As-Built Baseline Monitoring Report

Little Pine Creek II

Monitoring Year 0

Subject: Draft Baseline Monitoring Report (MYO)
Little Pine Creek II Mitigation Project, Alleghany County
DMS Project # 856
DEQ Contract #LP082819

NC Center for Geographic Information & Analysis

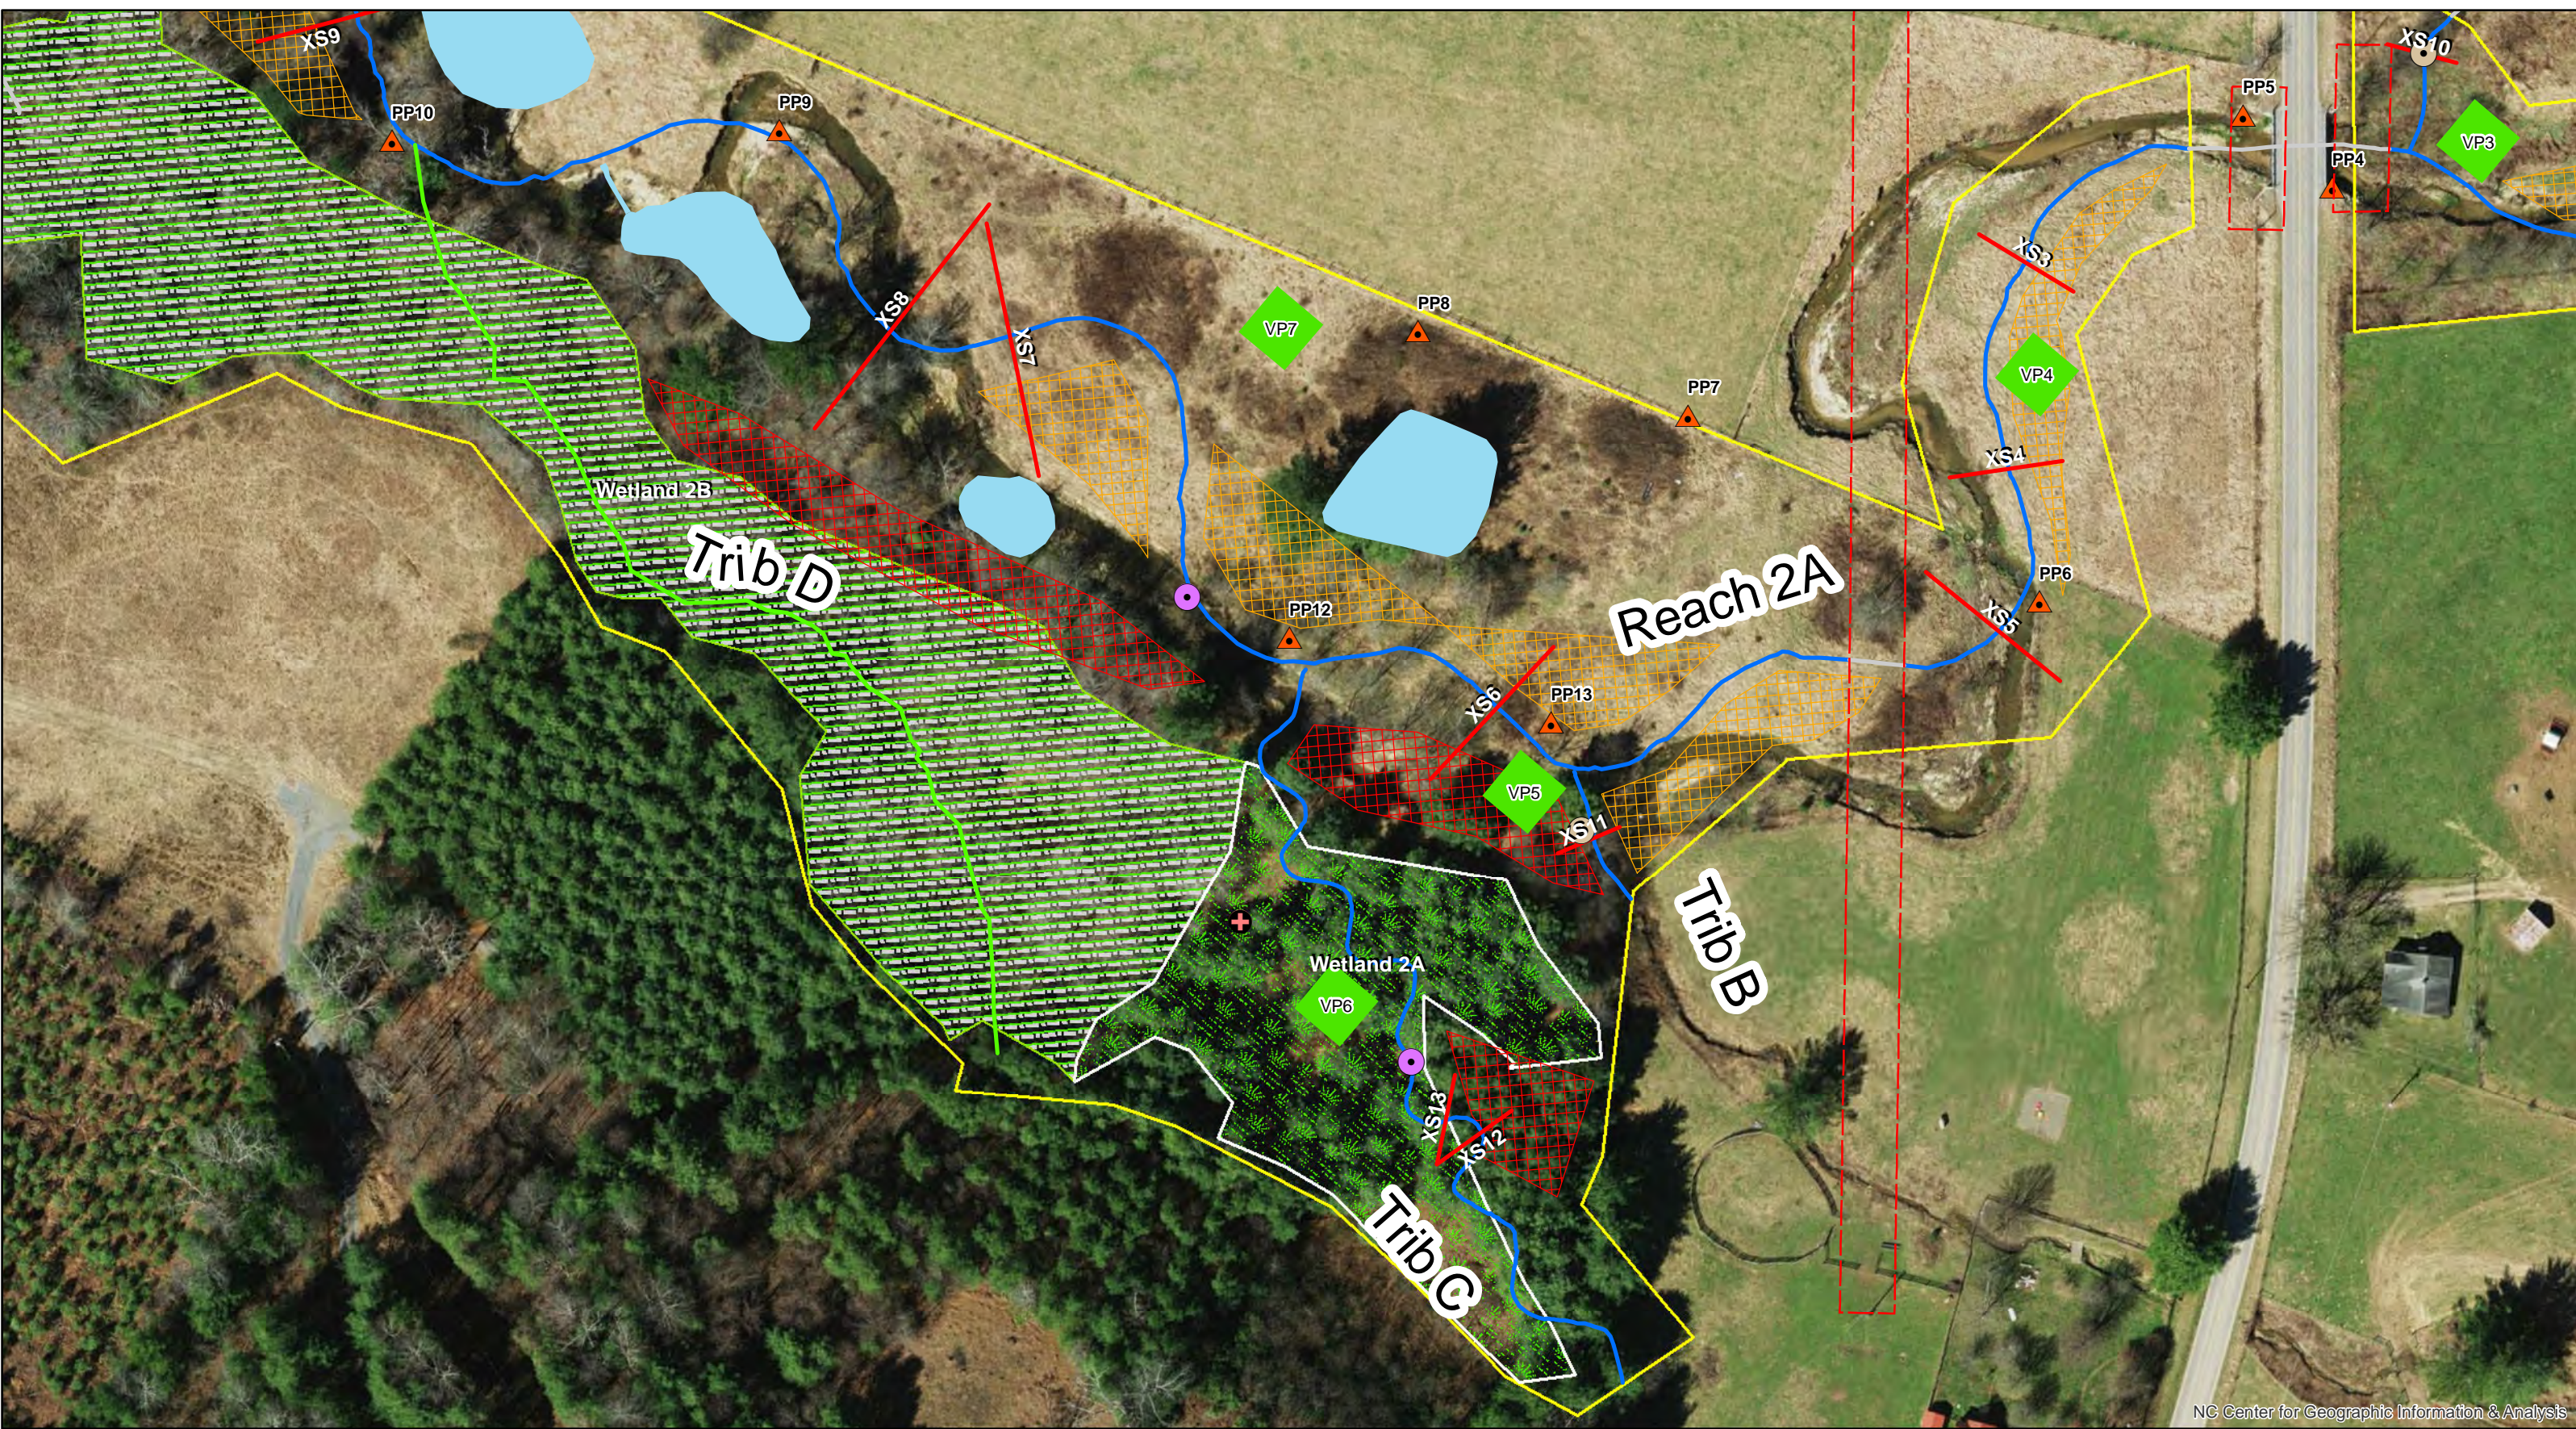
- *Maps – CCPV, Assets/Components, and Monitoring features should all be combined, and split into 3 detail maps (Generally, LPC Reach 1, Reach 2A, and Reach 2B and surrounding areas). These are typically called “Integrated CCPV” Sheet 1, 2, etc. Zooming in will allow all features to be included on each sheet, enable a better resolution, and avoid redundancy. An overall CCPV sheet with the 3 sheets keyed out with an overlay would work well, so as follows:*

- *Little Pine Creek II Stream and Wetland Mitigation Site (Key).*
 - *Little Pine Creek II Integrated Current Condition Plan View (Sheet 1)*
 - *Little Pine Creek II Integrated Current Condition Plan View (Sheet 2)*

- *Little Pine Creek II Integrated Current Condition Plan View (Sheet 3)*CCPV, Assets/Components, and Monitoring features combined on reach scale detail maps.

- *Constructed vernal pools should be added to the CCPVs.*
Constructed vernal pools were added to the CCPVs.
- *CVS table – At construction close out, the designer certified that the site was planted at 605 stems per acre (4665 bare roots / 7.7 acres), per the construction contract (bid addendum 03, dated 9/28/2017); the site wide stem density (273 stems/acre) indicates high mortality or below the planting density requirement. Did Equinox find that the plots had planted stems that died, or just were not present in the specified planted density? Equinox notes (Sec 4.2.1) that field conditions during the assessments were made in conditions not favorable for identifying planted stems. What field conditions? Can Equinox advise on why the MYO numbers might be below success criteria?*
Equinox did not identify dead stems in the plots; stems were not present. Snow cover of approximately 3-4” and recent alluvial deposition were the field conditions which were unfavorable for assessment. Stems could have been covered by alluvial deposition or removed by high flows.
